**BEFORE THE
ILLINOIS COMMERCE COMMISSION
DOCKET NO. 00-0393**

**AFFIDAVIT OF
SIDNEY L. MORRISON**

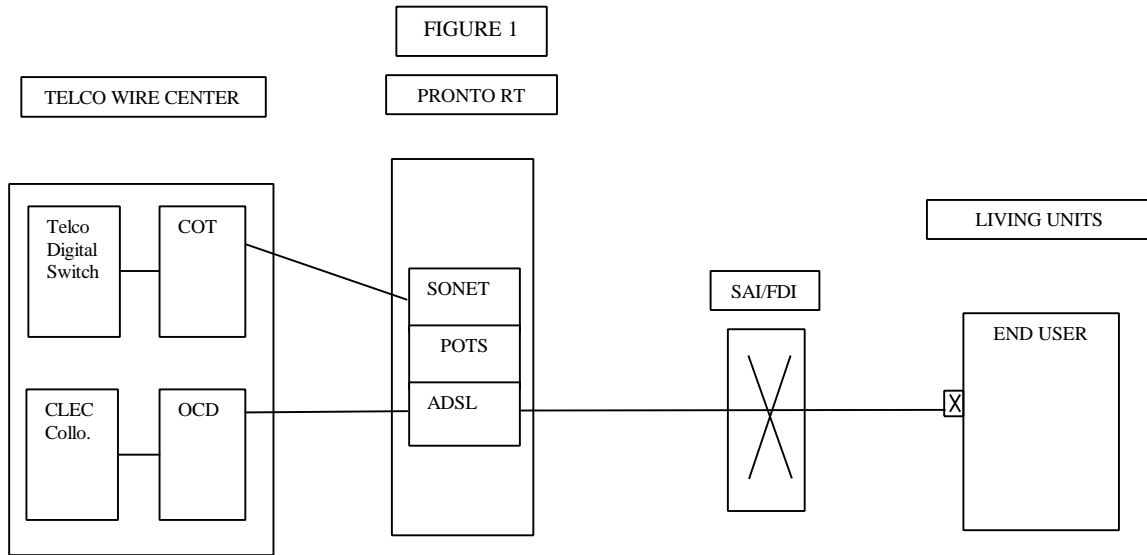
“In order to provision and ADSL service over this architecture a standard copper facility (analogous to a telephone line) is used to transport both voice and data from the end user customer premises to the NGDLC system placed within the RT site. This copper facility terminates on the back plane of the NGDLC system and is subsequently routed to a slot in a channel bank.”

In the Direct Testimony on Rehearing of Christopher J. Boyer, Page 22, lines 5 – 12, Mr. Boyer states again that the hard connection at the back plane of the RT is the reason the facility from the RT to the SAI/FDI can not be unbundled and must be used with the NGDLC to provide connectivity from the RT site to the user's customer premise.

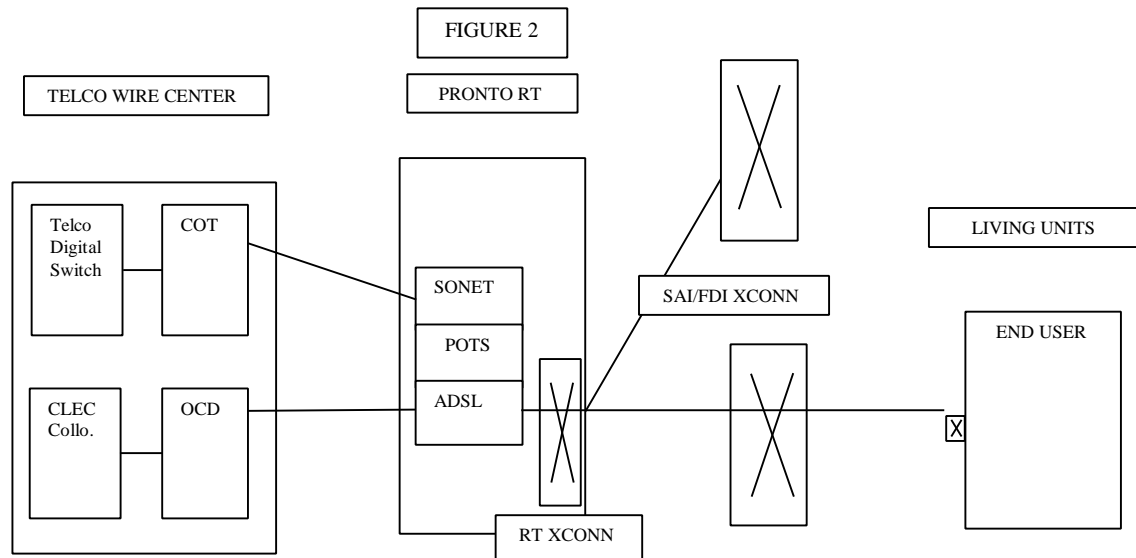
A. Yes, it could. By configuring the Project Pronto RT architecture in the manner described by Mr. Boyer (see FIGURE 1 below), Ameritech has, perhaps by design, made the option to provide unbundled network elements from the RT to

the SAI/FDI more difficult. It is important to note that this configuration is purely an engineering choice on the part of Ameritech Illinois.

The Project Pronto configuration could easily be reconfigured to provide maximum flexibility at the RT (see FIGURE 2 below) by employing a simple cross connect facility linking the remote terminal site with all SAI connections it supports. The architecture described below in FIGURE 2 would provide an additional cross connect point to facilitate unbundling the network elements consisting of the RT and the distribution cable pair to the SAI/FDI. Additionally, the RT cross connect point is advantageous for Ameritech Illinois. If a cable pair between the RT and SAI/FDI becomes impaired and can not be repaired or repaired in a reasonable time, the cable pair to the RT back plane can be changed without the complexities needed to change cards and the associated time slot changes to the central office, COT, and address changes for the ADSL service. The Project Pronto architecture described by Mr. Boyer would expose the back plane, slot and

card to the same risk as the cable and pair between the SAI/FDI and the remote terminal without any ability to quickly separate the two and reconfigure a workable solution.

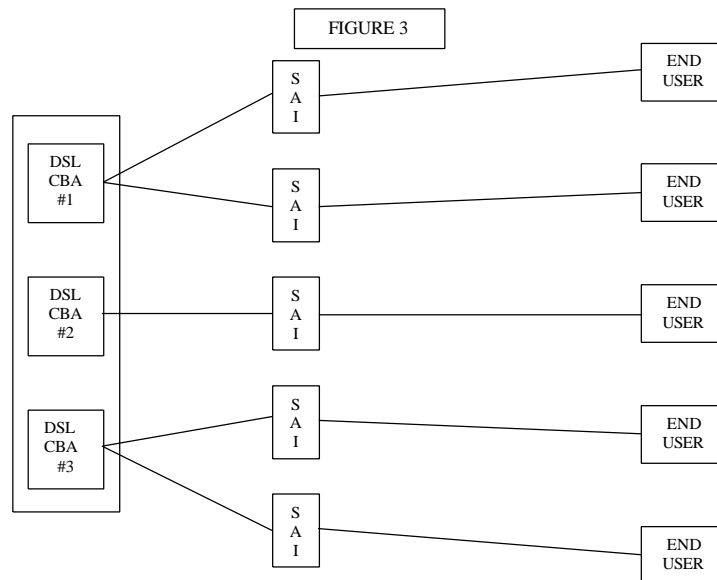
The above statement is true as the Project Pronto architecture is illustrated in Mr. Boyer's testimony attachment CJB-6. I've included a similar diagram in FIGURE 3 below demonstrating that indeed, if a CLEC owns the PVP serving a DSL CBA #2, given Ameritech's proposed architecture for its Pronto network, other carriers could be precluded from providing service to the end users accessed through the SAI connected to DSL CBA #2.

However, there is a fundamental problem with the design of the RT and the SAIs it is capable of accessing as described in FIGURE 3. FIGURE 3 illustrates that DSL CBA #1 and #3 cannot access customers in the SAIs being served by DSL CBA #2. When DSL CBA #2 becomes exhausted for any reason, i.e. PVP exhaust, port exhaust, etc., there is no ability in the design that allows excess capacity from DSL CBA #1 and #3 to provide relief for demand in the DSL CBA #2 serving area interface. Complicating matters is the possibility that demand in DSL CBA #2 will go unmet while unused capacity in DSL CBA #1 and #3 could

be stranded as a result of lower demands in their serving areas. This is an important flaw in the Ameritech architecture as described by Mr. Boyer.

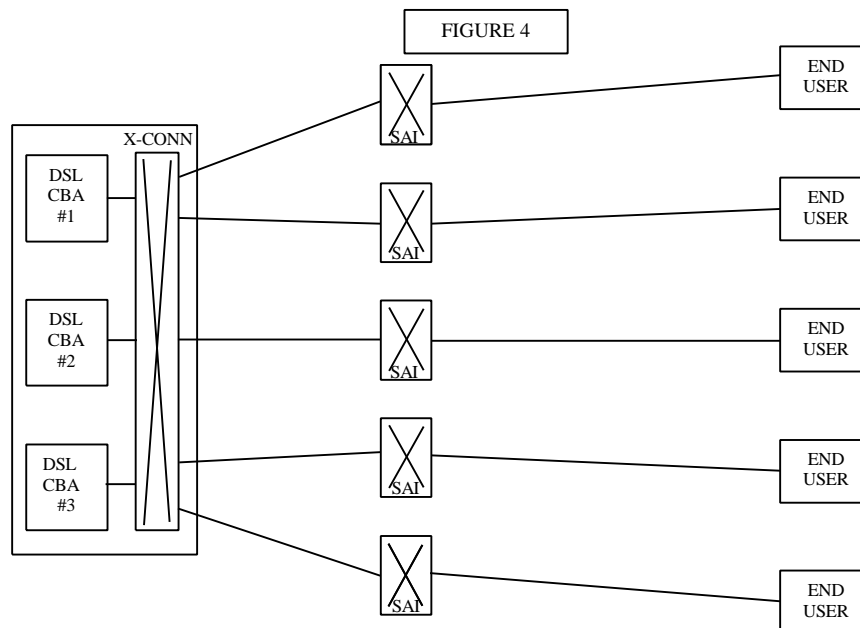
A. I've included as FIGURE 4 below an illustration of how Ameritech could employ the same cross connect management method I described earlier to provide maximum flexibility and eliminate the risk of stranded capacity. This same system would allow a CLEC to own a complete DSL CBA and not exclude other CLECs from accessing that, or any other SAI (or the customers served by any SAI). An additional benefit is realized when growth is needed. Growth can be added one shelf at a time and utilized to service any of the SAIs relying upon the remote terminal.
